PNNL-21546

Evaluation of Manual Ultrasonic Examinations Applied to Detect Flaws in Primary System Dissimilar Metal Welds at North Anna Power Station

June 2012

Figure 3. Sound Field Simulations and -6 dB Filter

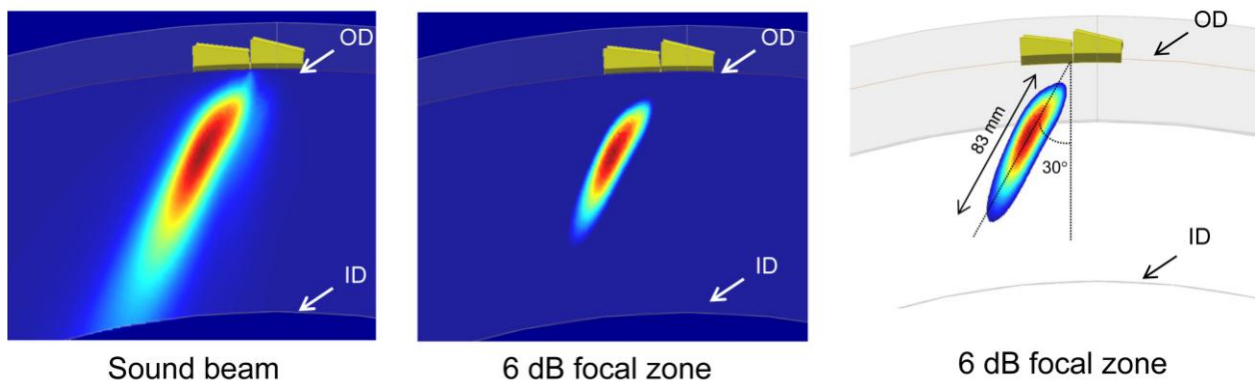
Sound field simulations showing the acoustic beam density generated by the tandem probe are displayed in Figure 3. As depicted, simulated sound field energy increases from blue to red. The first image shows an unfiltered sound beam in the specimen; OD and ID surface locations are indicated. The middle image has a -6 dB filter (50% threshold) applied that highlights a -6 dB focal zone. The image on the right of Figure 3 has the same -6 dB filter applied without the full computational zone visible, emphasizing the insufficient extent of the -6 dB focal zone (or highest intensity sound field) to reach the specimen ID surface region. The model indicates that this probe configuration is sensitive to longitudinal mode ultrasonic energy at a refracted angle of 30 degrees (not the licensee-designed 40 degrees), with the maximum value of sound field intensity located at 44 mm (1.73 in.) from the OD along the metal path. This result is based solely on probe specifications provided to PNNL by Sigma Transducers (probe manufacturer), and has not as yet been validated through empirical testing. The -6 dB focal zone length along the metal path is 83 mm (3.27 in.) or only 56% of the entire through-wall metal path. The required metal path at 30 degrees to reach the ID is approximately 148 mm (5.83 in.).

Figure 4. Simulated Sound Field at ID with a −12 dB Filter

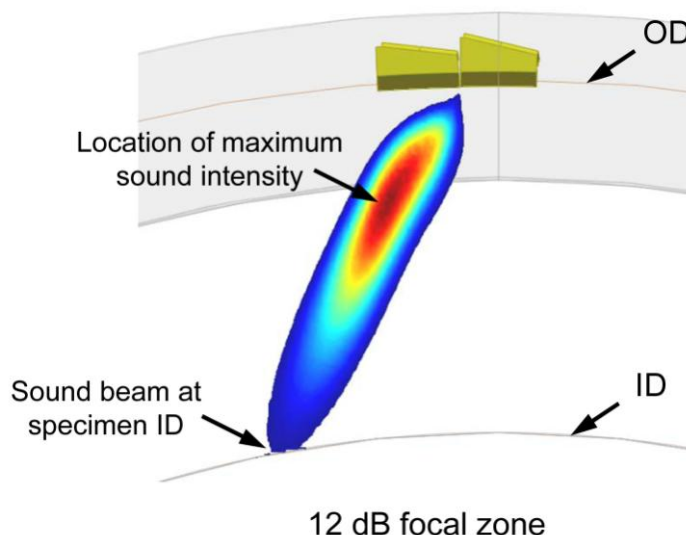
The simulated sound field was projected to the specimen ID, but was substantially diminished in strength (−12 dB level). The image with an applied −12 dB filter is shown in Figure 4. A drop of 12 dB from the maximum sound intensity is a ratio of 4:1. Therefore, only about 25% of the maximum beam intensity is predicted at the ID surface; this is optimistic, given that a homogeneous, isotropic material was modeled versus the anisotropic nature of the weld microstructure. This reduction in signal level predicts a poor signal-to-noise level for detection of ID surface-connected flaws via a corner-trap response. The results suggest the tandem probe may potentially be suited for detection of specular or tip responses from flaws in the outer 60% of the material (which has only been modeled as simple isotropic media), but extremely limited for detection of ID-connected flaws in this specimen configuration.

Figure 6. Mid-wall Fabrication Flaws or Implantation Artifacts Detected in North Anna Mock-ups (as indicated by arrow)

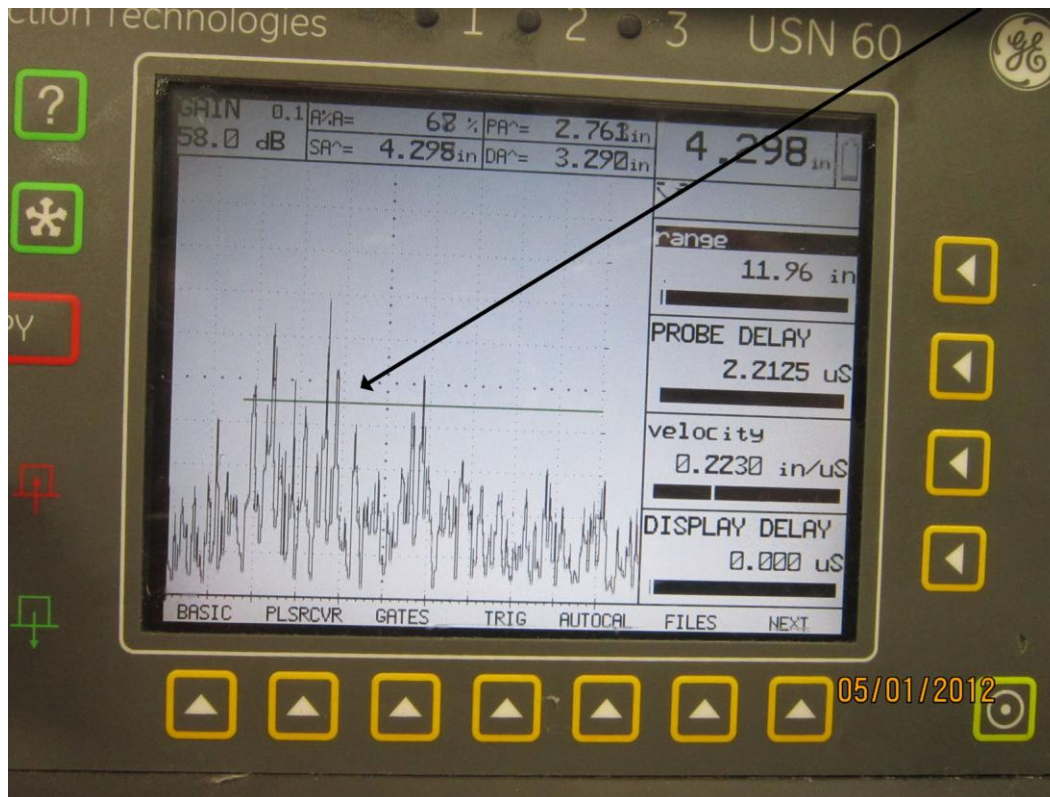
This mock-up has one axial flaw that is reported to be approximately 32% in through-wall depth. The flaw was ultrasonically located with the “LR” probe at a marginal 2:1 signal-to-noise ratio (SNR). This flaw was also detected in the opposite scan direction with the “RR” probe, but with much less than 2:1 SNR. Several other mid-to-upper wall ultrasonic responses were observed along the weld length; these are potentially welding fabrication or, based on the location detected, implantation artifacts from circumferentially oriented flaws in the mock-up. The presence of these “spurious indications” in near vicinity to axial flaws is unusual for a demonstration mock-up. Plant-specific demonstration mock-ups should be used to train qualified examiners with respect to the special conditions that will be encountered in a particular examination. Normally, such mock-ups are fabricated such that flaws are discrete and highly detectable, so that examiners can be trained with respect to discriminating flaw responses from other reflections. The poor SNR and spurious indications made detection in the licensee’s mock-ups significantly challenging, even when the locations of the targeted axial flaws are known. Figure 6 provides an example of the A-scan results showing typical mid-wall indications.

General observation—Given these mock-ups are claimed to be designed/fabricated to be consistent with ASME, Appendix VIII (ASME 2007), one would expect less inadvertent fabrication flaw, or implantation artifact, responses to be present. The UT responses from these artifacts, or weld fabrication flaws (this remains unclear), significantly impede detection and characterization of the axial flaws. Based on the site observations, there are too many transient indications detected on the North Anna mock-ups that interfere with targeted flaws for one to clearly assess the effectiveness of this non-encoded, manual system to detect the implanted cracks. Typical A-scan images for the flaws and other pertinent reflections on DM-05 and DM-10 are included as Attachment B.

Figure B.3. DM-05 End-of-Block Through Safe End

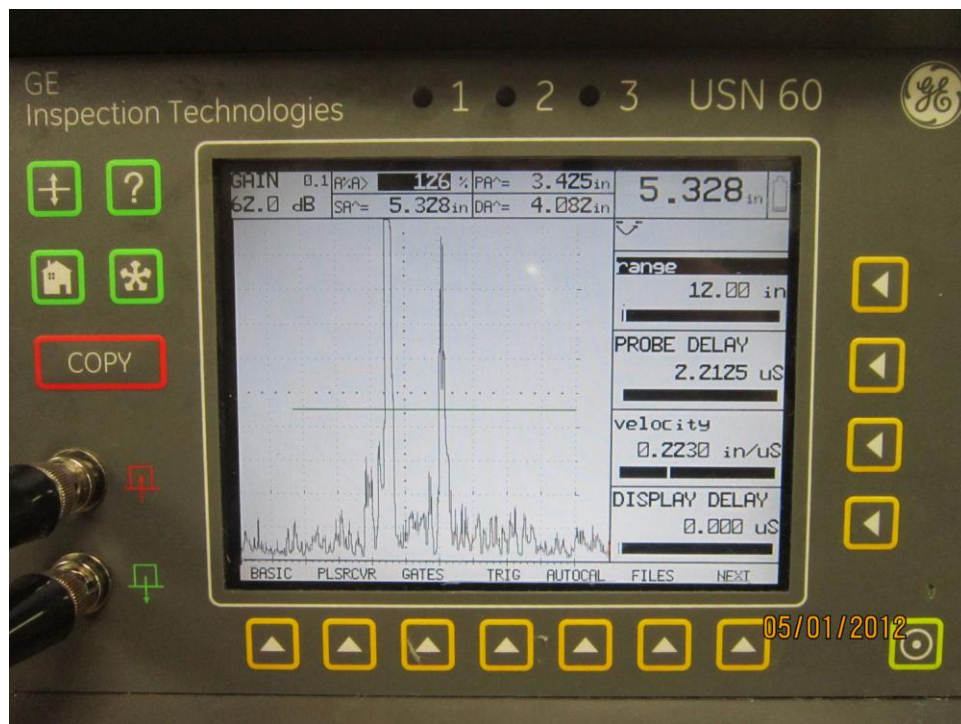
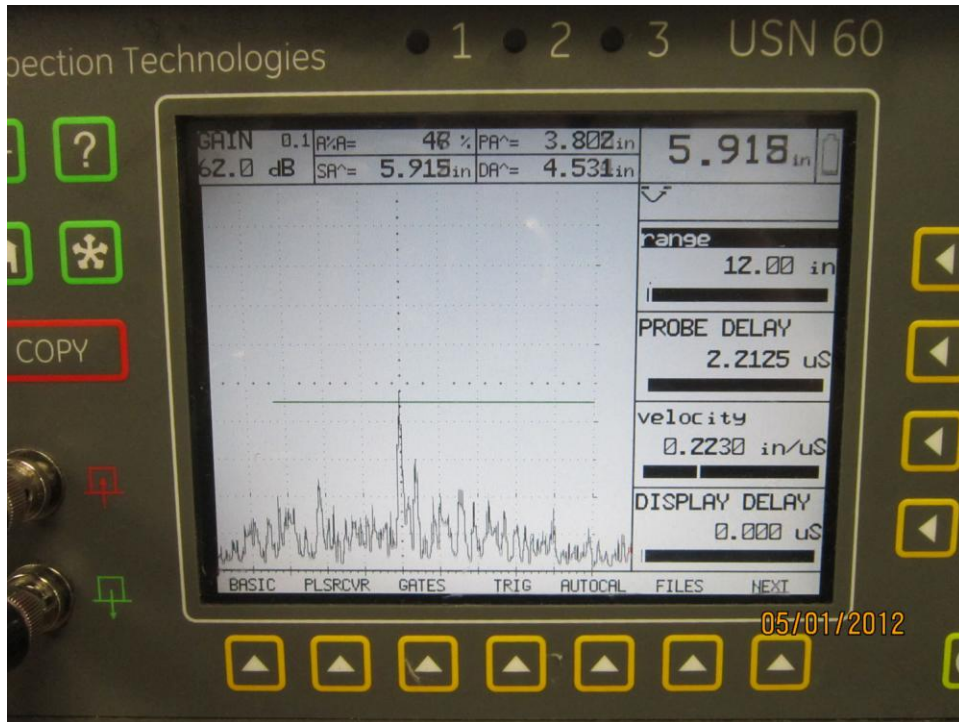
The end-of-block response from the mock-up, which represents a 100% through-wall surface, was very easy to detect when scanning from the wrought safe end, but exhibited a significantly lower response when scanning through the weld material. In addition, the UT response from the end-of-block appeared to be slightly shifted out in time, indicating the weld microstructure may be re-directing the primary sound beam “upward” or at a higher inspection angle. There was a noticeable difference in sensitivity between the LR and RR tandem probes—this was on the order of 4 to 6 dB—and each set of probes exhibited a high-pitched “whine.” This is unusual for an ultrasonic probe designed at this frequency when inductive tuning is not applied. As such, the cause for this whining noise is not understood.
